## **Lowestoft Town Council**

## Notes - Toilet Strategy Working Group 2020-12-17

## **Sparrows Nest**

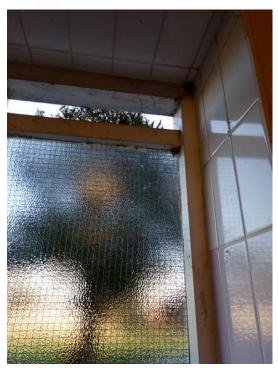
Concern was expressed at the failure of areas of wall tiles, possibly because of damp entering the fabric of the building, originating from springs along the cliff face to the rear. In actual fact there is a courtyard between the rear of the toilets and the Lowestoft War Memorial Museum, which does back on to the steep banking.

The affected areas of failed wall tiles are in the vicinity of ventilation openings, as shown:-

To avoid ingress of water or excessive damp, it is suggested that these openings be replaced by sealed double-glazed windows, with motion-activated lights and an extraction fan in each toilet. The condition of the locked disabled toilet is not known.
